**EPA Development Application Referral Response**

<b>Development Application Number</b>	<b>21031284</b>
<b>Applicant</b>	<b>Mr Timothy Beazley</b>
<b>Location</b>	<b>160 Longview Road Heathfield SA 5153</b>
<b>Proposal</b>	<b>24-hour retail fuel outlet with associated canopy, car cleaning and dog wash facilities, 70,000L underground fuel storage tank, pylon advertising sign, combined fence and retaining walls, car-parking and landscaping.</b>

## **Proposed OTR Service Station, 160 Longwood Road, Heathfield Acoustic Peer Review**

### **PROPOSED RETAIL FUEL OUTLET – 160 LONGWOOD ROAD, HEATHFIELD**

Figure 1: Required MGSD for a driver turning right to the proposed car wash

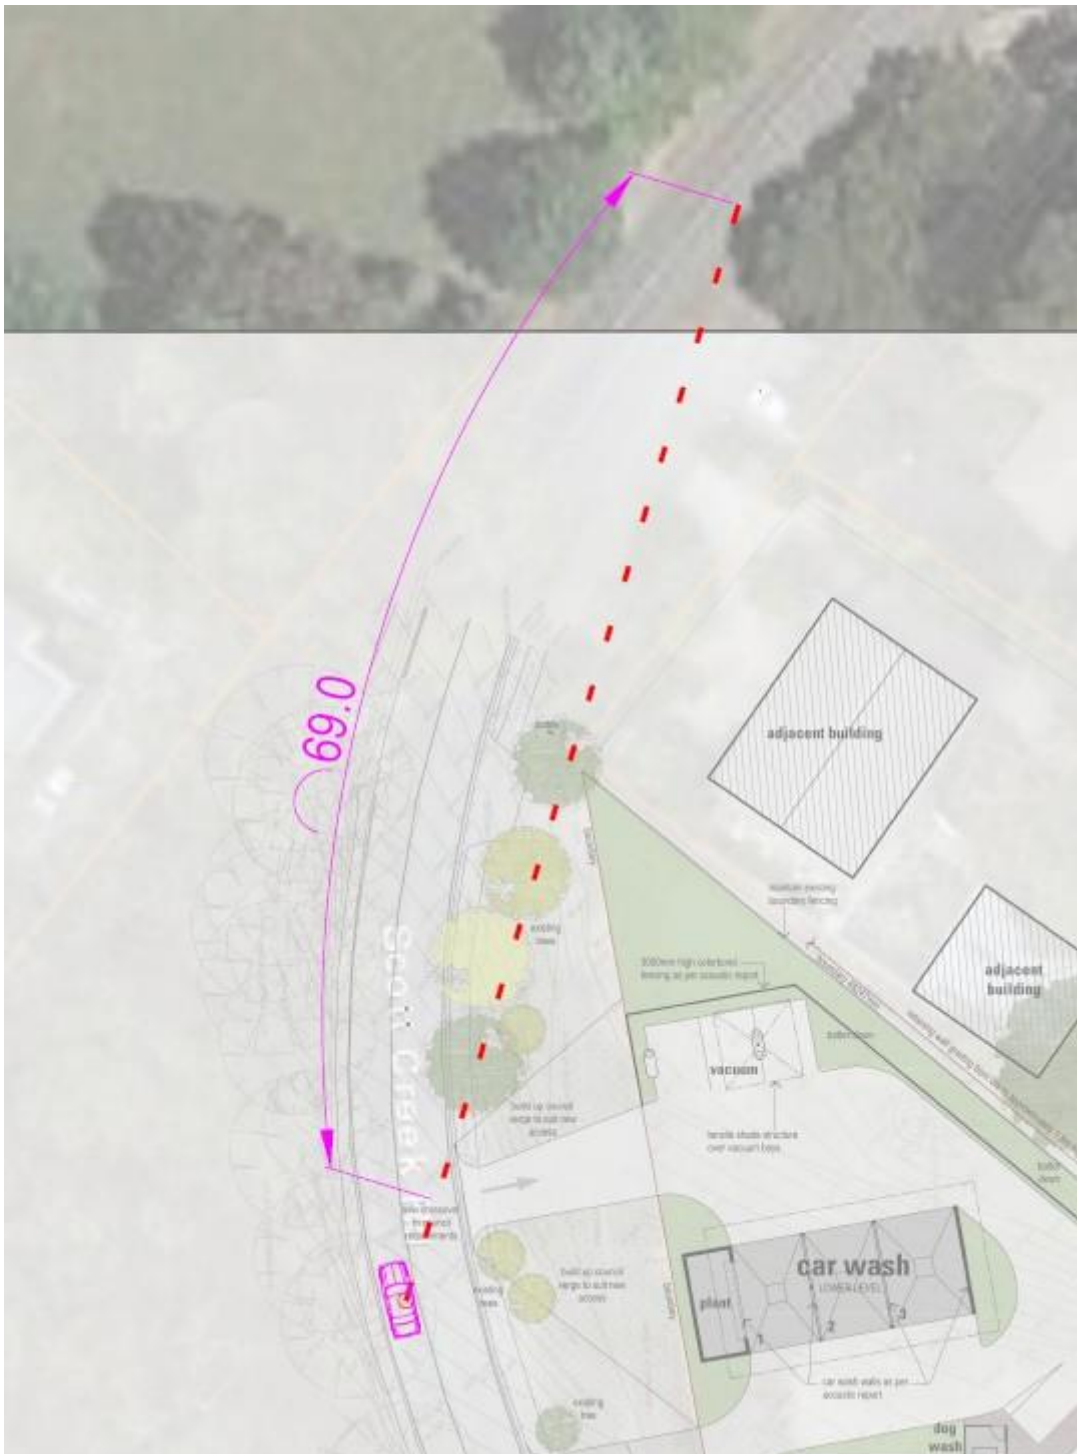
Adopting the above criteria, I have reviewed the sight distance at the proposed access points. Figure 1 illustrates the MGSD at the proposed car wash ingress.

It can be seen from the above that the sight distance could be met subject to the vegetation being removed within the verge.

Figure 2: Required SISD(EDD) and MGSD for a driver exiting the proposed car wash

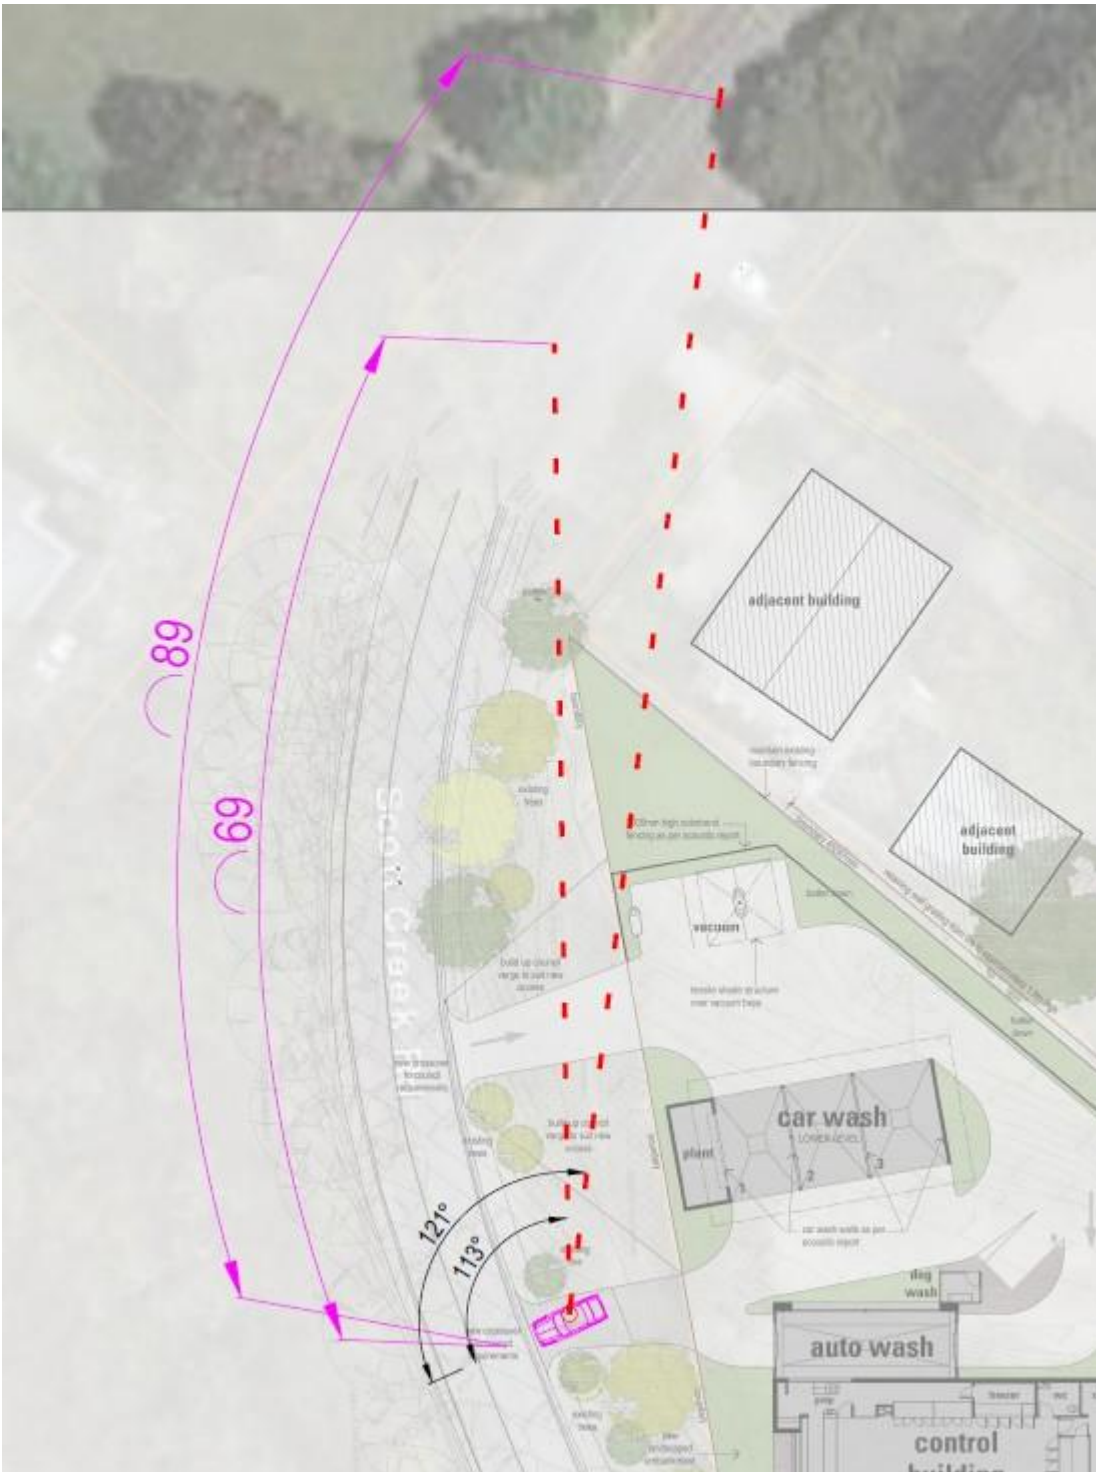
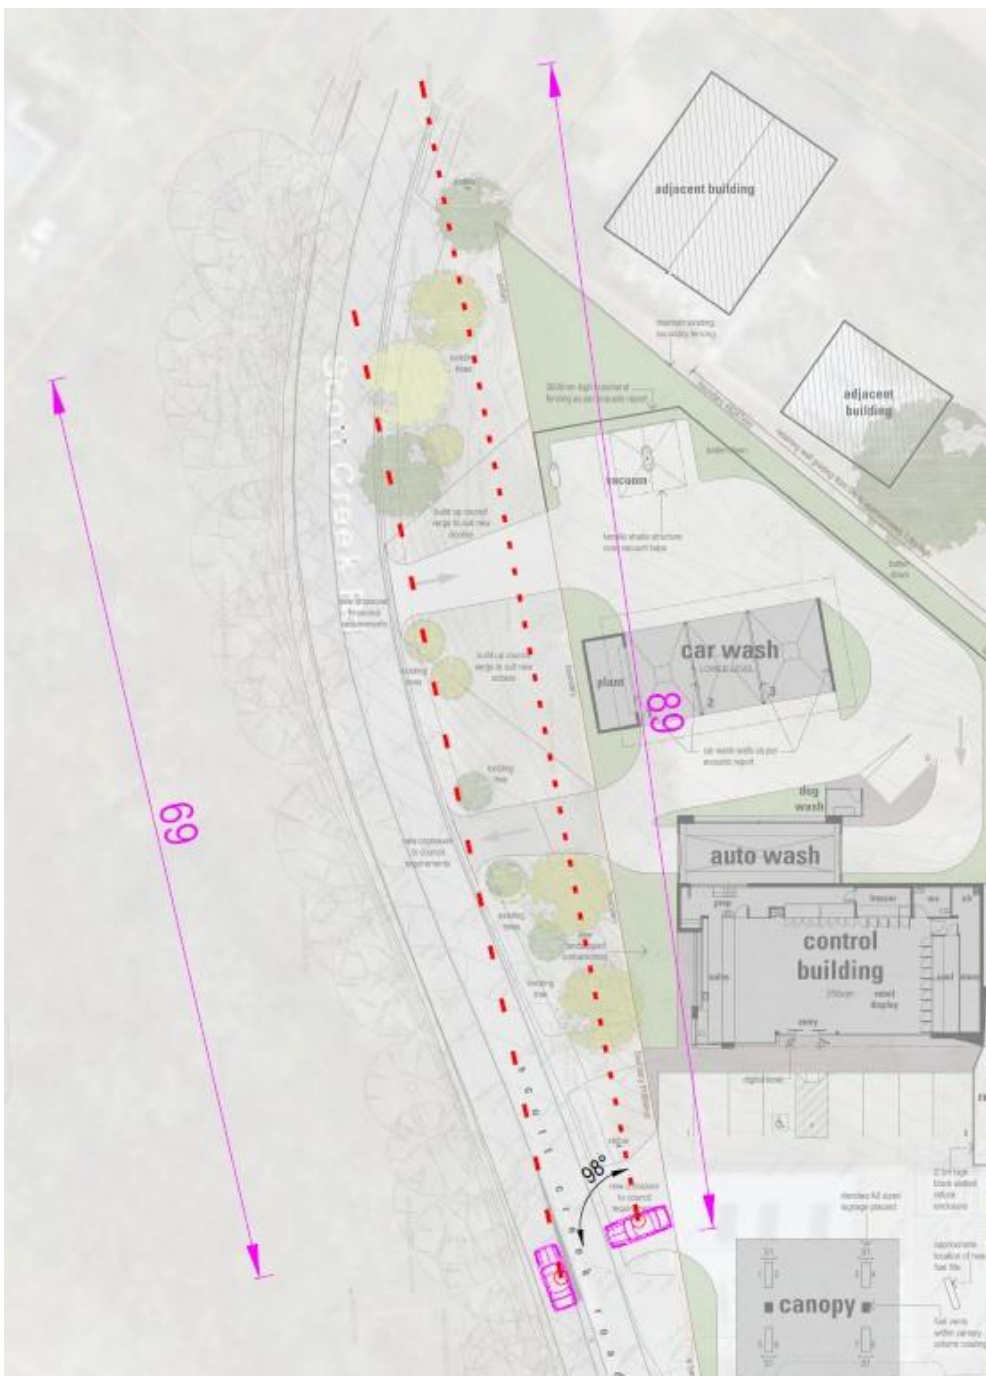
Figure 2 illustrates the SISD(EDD) and MGSD for a driver exiting the proposed car wash, having regard to the angle of observation in addition to the distance required.

It can be seen from the above that the SISD(EDD) could not be met for drivers exiting at the proposed car wash egress. Even if the vegetation in the verge was to be removed and the marginal non-compliance of the sighting angle accepted, the line of sight for drivers would be across the neighbouring property and would be obstructed by fences.

**Figure 3: Required SISD(EDD) and MGSD for a driver accessing the proposed retail fuel outlet on Scott Creek Road**

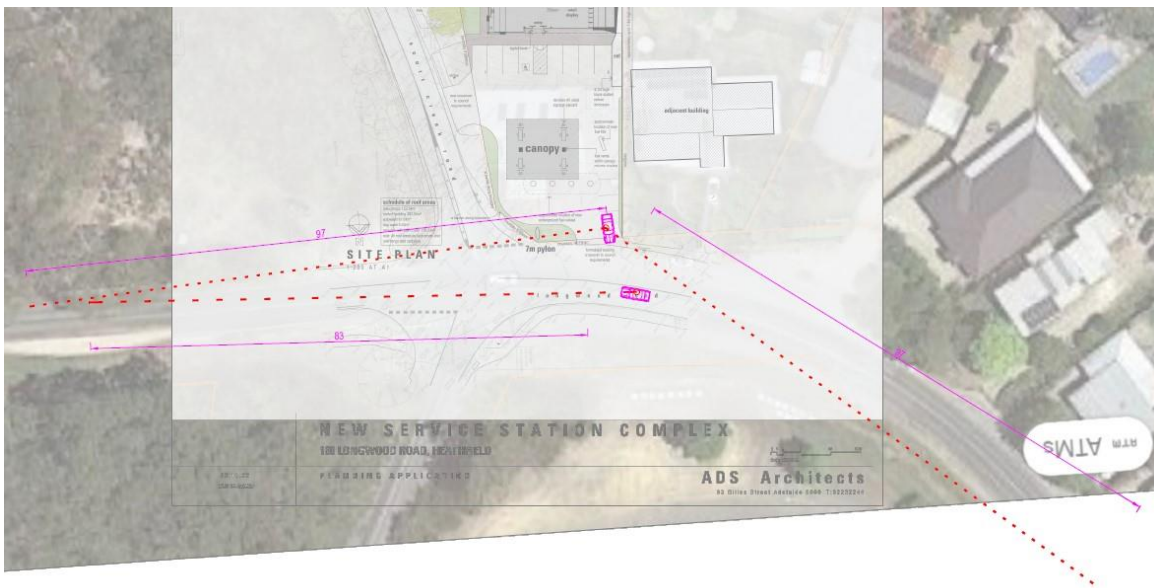
Figure 3 illustrates the SISD(EDD) and MGSD for drivers using the proposed access to the retail fuel outlet on Scott Creek Road.

It can be seen from the above that the sight distance requirements could be met at the access, subject to removal of most of the vegetation in the verge.

**Figure 5: Proposed Longwood Road access relative to the prohibited access zone for the Longwood Road/Scott Creek Road intersection, as defined in Figure 3.3 of AS/NZS2890.1:2004**

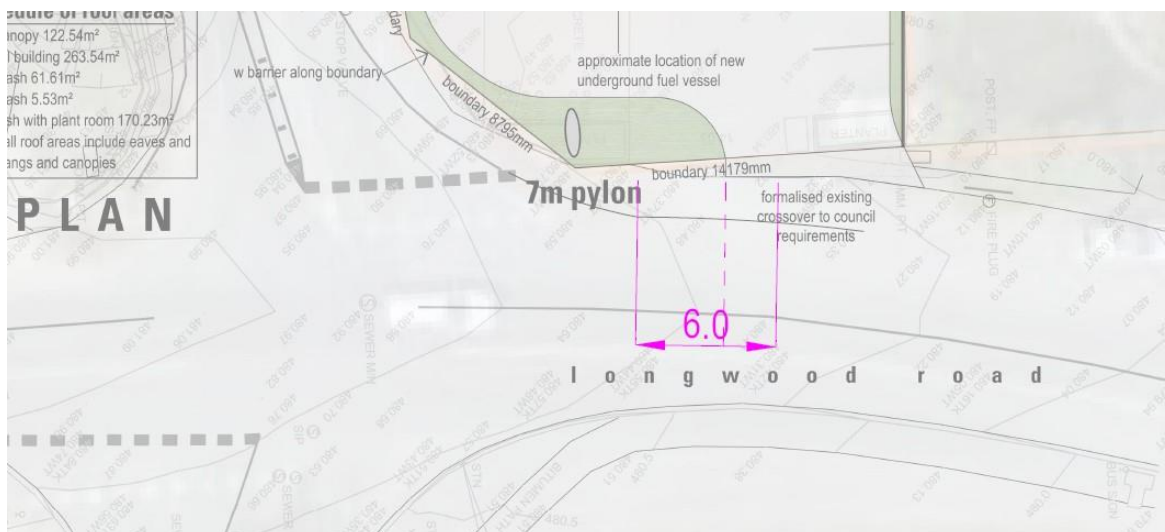
It can be seen from the above that the minimum sight distance requirements will be met for a driver entering and exiting the site on Longwood Road, albeit the sight distance for pedestrians as identified in AS/NZS2890.1:2004 is not provided at the proposed access. Notwithstanding this, the proposed access will be located within a prohibited access zone, as illustrated in Figure 5.

The above figure identifies that the proposed Longwood Road access is much closer to the intersection than permitted in the Standard. While there is an existing access at this location, the proposed development will significantly increase the volumes using the access and will therefore change the nature and function of the access and the category of the access.

Based on the above assessment, therefore, it is considered that minimum sight distance will not be provided at the proposed access points and the Longwood Road access would be within a prohibited access zone.

**Figure 6: Queued vehicles at pumps obstructing access to refueling lanes**

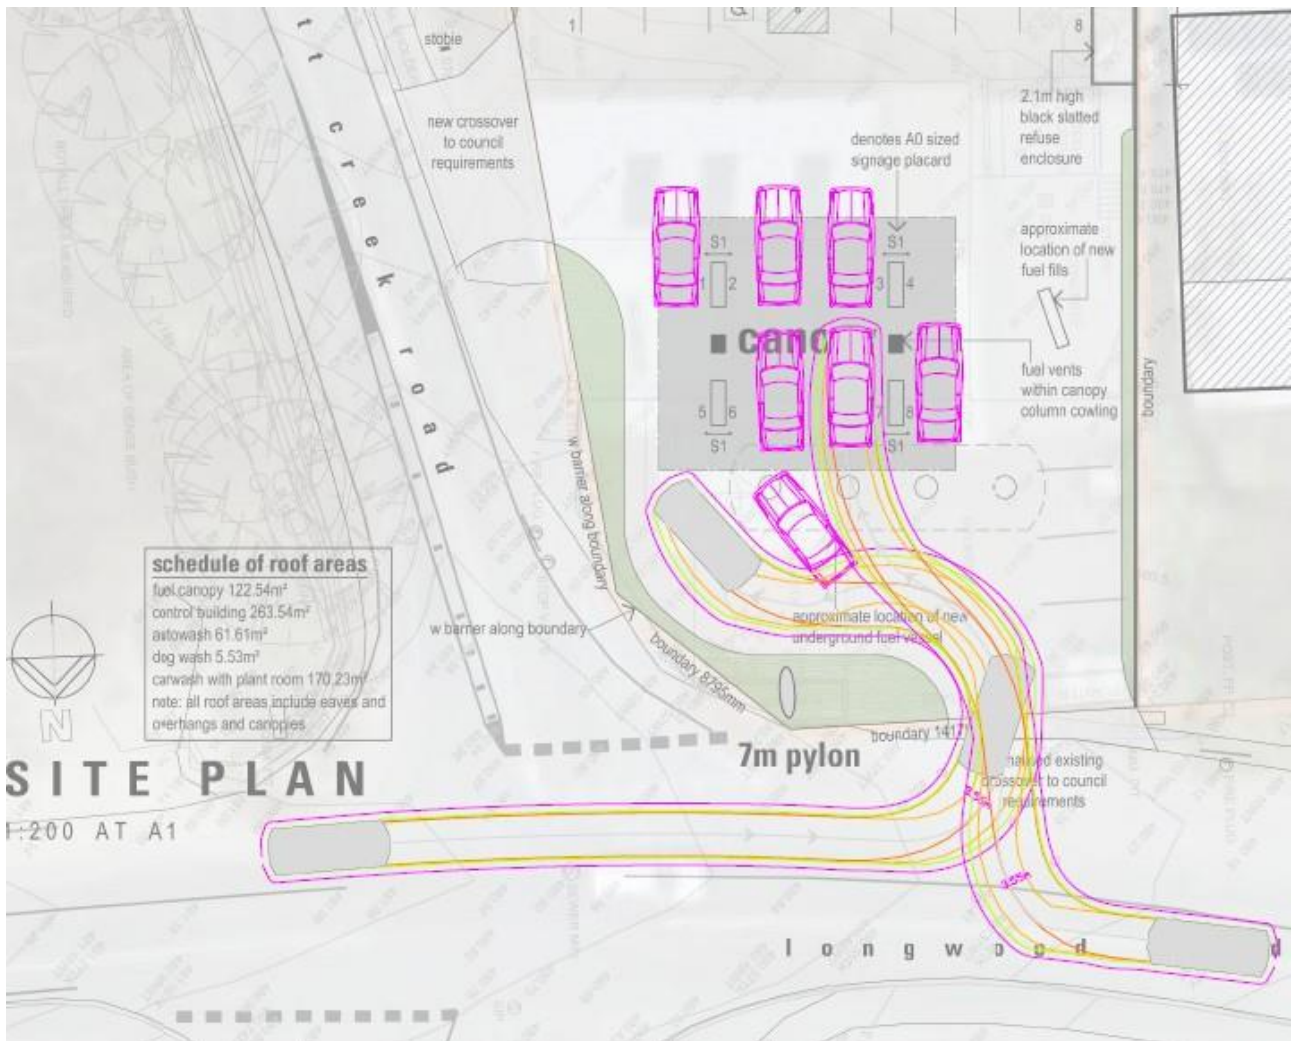
Drivers will typically access the site such that the vehicle is positioned facing the control building. Queues at the pumps will potentially obstruct access to the fuel pumps, as illustrated in Figure 6.

The above issue will potentially be further compounded if the queued vehicles are not precisely parked adjacent the fuel pumps, given that the pumps are proposed to be located with less separation than would typically be provided.

Figure 6 also demonstrates that the vehicle position at the front fuel pump would extend into the travel path of an exiting vehicle, thus creating a potential crash risk.
